NAME: INSTALLATION - FURN. - "RU" RECEIVERS & RADIO OPERATOR'S VISUAL INDICATOR

CONSOLIDATED AIRCRAFT CORP. — SAN DIEGO, CALIF.

J 28F5372

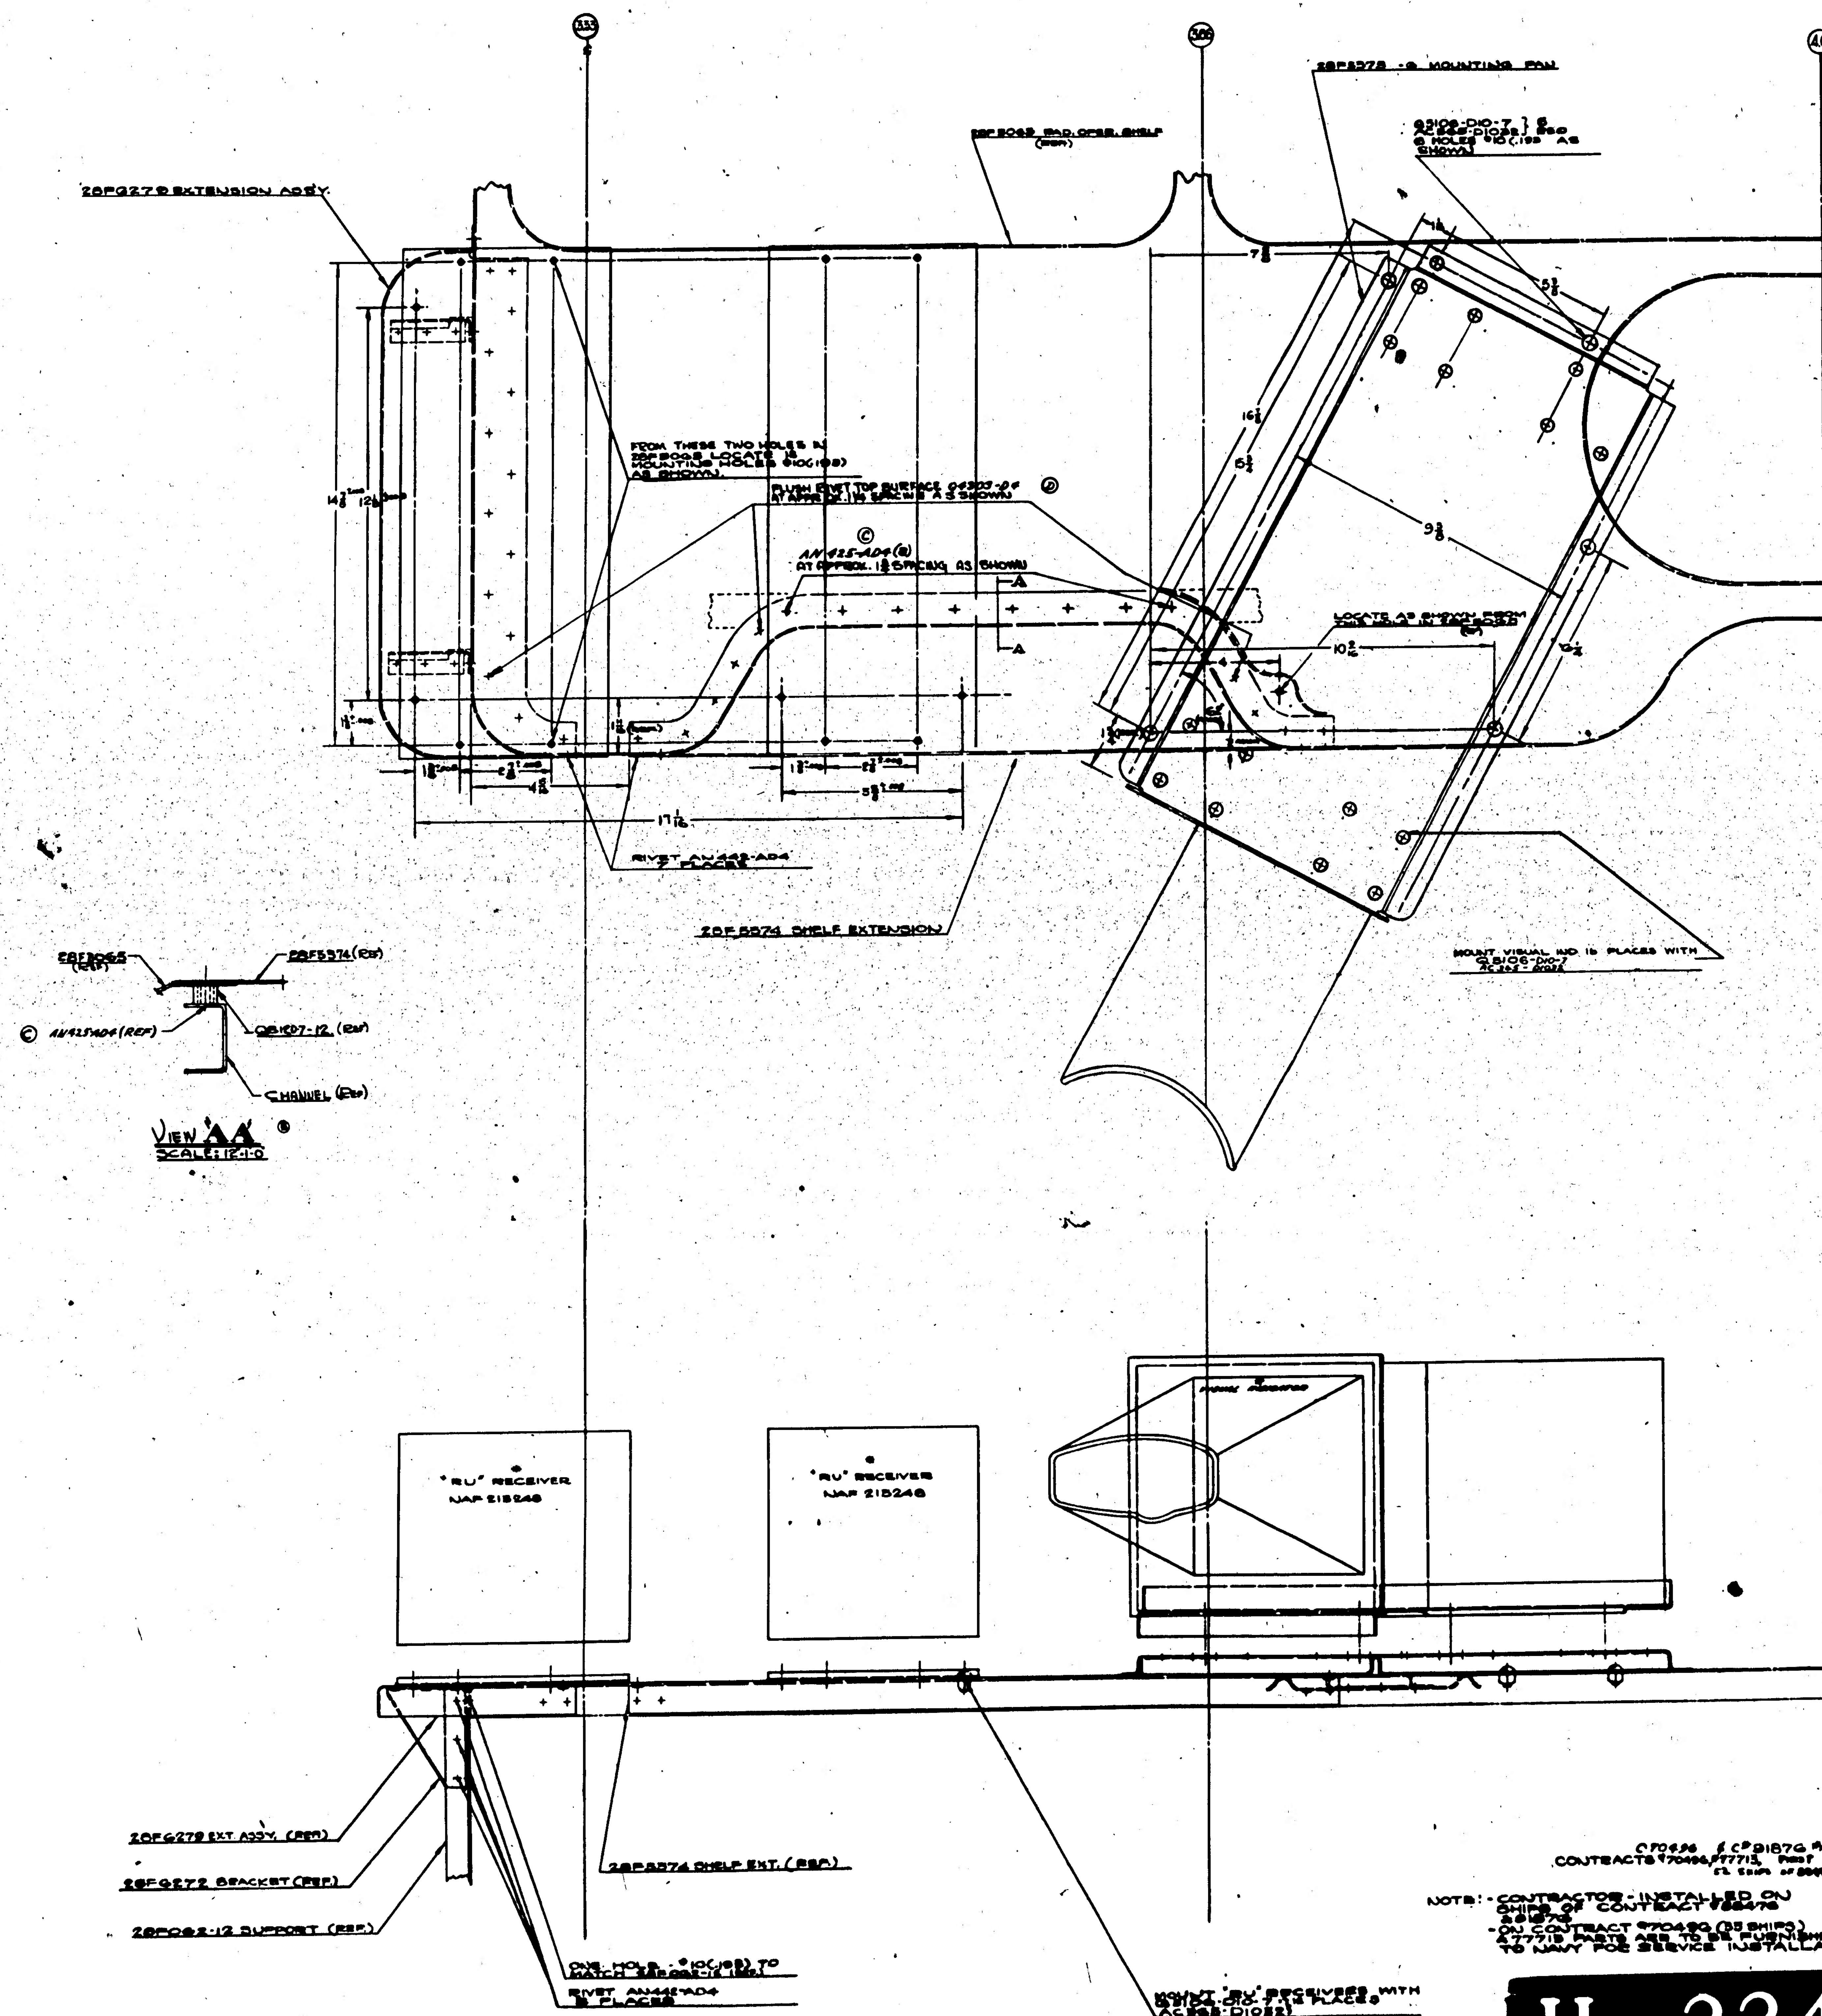
REV.	ALTERATION	DATE	BY	REV.	ALTERATION	DATE	BY
				A	[illegible] - RELEASE	[illegible]	[illegible]
				B	REPLACED AN425-AD4 RIVETS	[illegible]	[illegible]
					[illegible] AC365-D1032 & Q8507-12		
					ON 28F5374 ATTACHMENT		
					-REMOVE 28F5375 & AN442-AD4		
					ATTACHING RIVETS		
					-RE-LOCATE 28F5373-6		
					PAN & MOUNTING HOLES		
					-ADDED VIEW "A-A"		
					-REVISED "B.M." TO CONFORM		
				C	-REPLACED (.193) HOLE (8),		
					Q5106-D10-12 (8), AC365-		
					D1032 (8) & Q8512-8-24F (8)		
					WITH AN425-AD4 (8) (WT. CHG. NEG.)	[illegible]	[illegible] PER E.O. A31930
				D	IN NOTE "FLUSH --- SHOWN"		
					Q4303-D4 WAS AN425-AD4		
					(WT. CHG. NEG.)	[illegible]	[illegible]
